DEVELOPMENT SPECIAL USE PERMIT #2003-0019 THE MONARCH (HENNAGE PRINTING)

CITY OF ALEXANDRIA
PLANNING COMMISSION
NOVEMBER 4, 2004

DSUP #2003-0019

Proposed Oronoco Street Elevation with Staff Recommendations

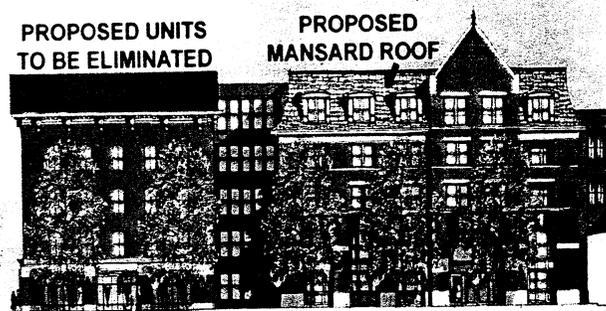
The Oronoco Street Facade is one of the shortest elevations and contains the principal entrance for the condominium building on the south half of the site. The proposed building consists of three sections facing Oronoco Street: the three-story, mixed-use element from the corner at Henry Street; the central portion which contains the entrance in a Queen Anne or late Victorian mixed-use building; and a 5-story level commercial type building at the corner of Fayette Street. The three buildings are connected by two architectural hyphens that serve as internal walkways for the units. The hyphens are setback approximately 30 feet from the face of the adjacent buildings and reinforce the impression of separate architectural pieces. The overall composition of mixed-use multi-family buildings is a reasonable approach but the scale of the proposed 5-story element at the corner of Oronoco and Fayette Streets is too imposing for the adjacent neighborhood, both in its height approximately 50 ft. feet and in the monumental language of three-story columns, large-scale windows, heavy entablature, etc.

Therefore, staff recommends that the corner element be reduced in its visual impact, both by modifying the style to a less grandiose expression and by eliminating a portion of the fifth floor so that the building will appear as a four-story building from the adjoining streets. This modification will result in the elimination of approximately three units. The elimination of the units also occurs on the accompanying Fayette Street facade and is essential to enable a better transition to the adjoining two-story buildings.

N. Henry St. without recommended changes ***N. Henry St. with staff recommended changes***

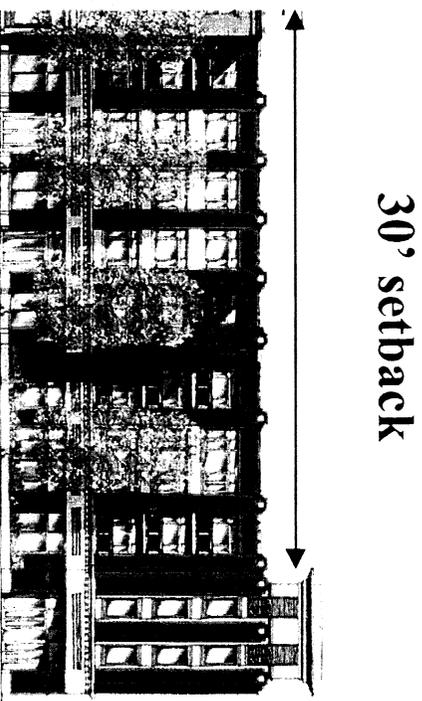
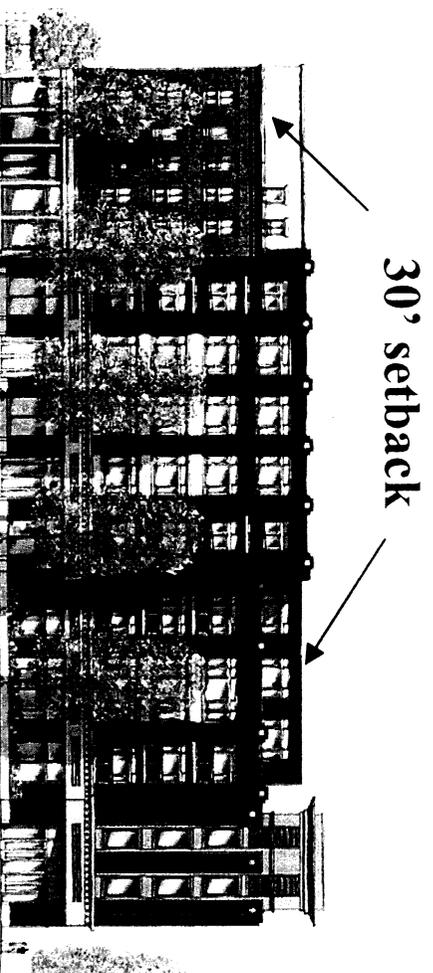
However, staff remains concerned with the massing on North Henry Street and the massing at the corner of Oronoco Street and North Fayette Street, the two locations where the proposal abuts the more traditional scale of Parker Gray and the primarily 2- to 3-story buildings on North Henry Street. To address this issue, staff is recommending that approximately 5 units be eliminated to create a better transition in scale to the adjoining neighborhood and primarily 20 ft. to 25 ft. tall buildings that are typical of the buildings on North Henry Street and the buildings within Parker Gray. By reducing the overall mass and revising the design, the proposal will be more compatible with the existing character and development pattern of the neighborhood and building styles more typical of Alexandria. Staff is also recommending the building design be revised to be more similar to building types and forms typically found in Alexandria.

- s. The two recessed architectural hyphens shall be a dark green metal cladding with traditional two-over-two windows.
- t. The central and western portion of the facade shall be revised ~~by eliminating two units~~ as generally depicted in *Attachment # 2*. The roof for the upper floor shall be slate or synthetic slate.
- u. The recessed upper level shall be a lighter color brick. The fenestration for this level shall be similar to the facades for each "building."
- v. The screening for the mechanical equipment on the corner shall be constructed of same masonry material as the primary facade.
